Problems with LibertyVote Upgrade Path to Lot 1 Machines

By Bo Lipari

February 7, 2008

System Name: LibertyVote (BMD) with EMS LibertyControl, EPU 1

The LibertyVote DRE

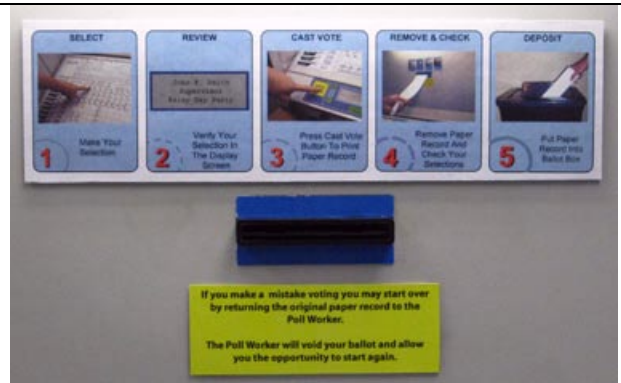
- In the LibertyVote DRE for Lot 1, the VVPAT slot located at the back of the machine is covered by clear plastic. This VVPAT is never removed or touched by the voter, as required by New York State election law.
- In the LibertyVote DRE being promoted as a Ballot Marking Device for Lot 2, the VVPAT slot is open, and the 'ballot' is ejected out of this slot.

Since the VVPAT slot performs different, mutually exclusive functions, any LibertyVote DRE purchased for use as a ballot marking device will not be able to be used in 2009 for lever machine replacement. Counties which purchase a LibertyVote DRE for the 2008 Lot 2 machines will not be able to use these machines in 2009, but instead must purchase completely new machines to serve non-disabled voters. This means that for each LibertyVote Lot 2 device purchased, an additional one must be purchased in 2009.

The VVPAT slot is enclosed behind clear plastic, and cannot be removed.

The LibertyVote "BMD"

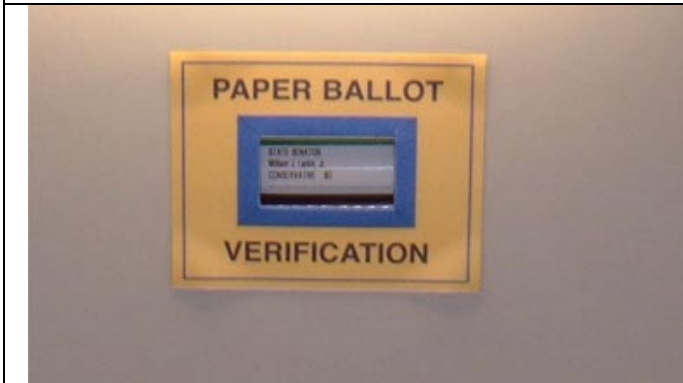
The VVPAT slot is open, and the 'ballot' is ejected from this slot.
